**R10RM**

# Rear Inner Bulkhead Panel Joint Strength Noncompliance

**Models Affected: Certain 2010 Model Year All American (D3RE) Rear Engine School Buses**

**Street Side:**

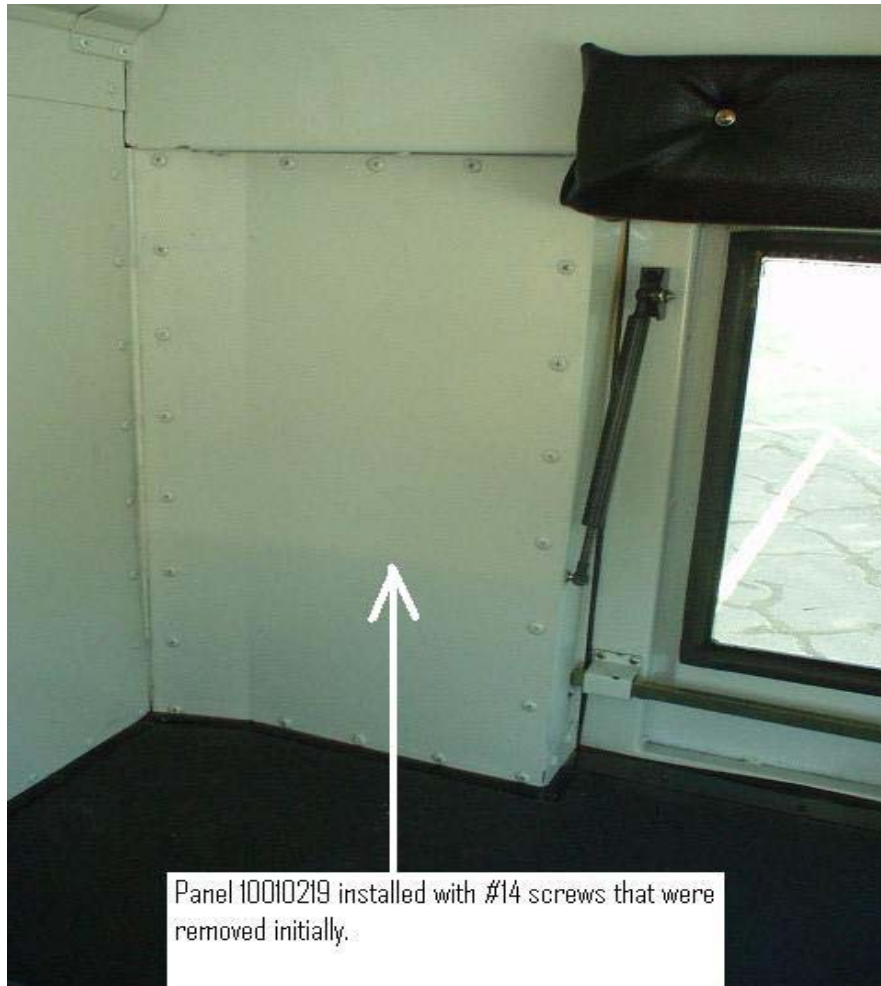
1. Remove panel without access panel and discard. Retain the screws. Sand the paint down to bare metal on the rear structure where the adhesive will be applied. Sand ½ inch on each side of screw holes. Be careful not to sand area that will not be covered by new panel. Wipe sanded area clean before installing adhesive.
2. Apply a ¼ inch bead of Magnabond adhesive in the center of the mating surfaces for the close-out panel along or near the screw line.
3. Install new panel (10015934) with #14 screws removed previously. Be sure to clean off any excess adhesive immediately before it has time to start curing.
4. Install access panel (10013015) with (6) 01164821 #10 x .75 screws.
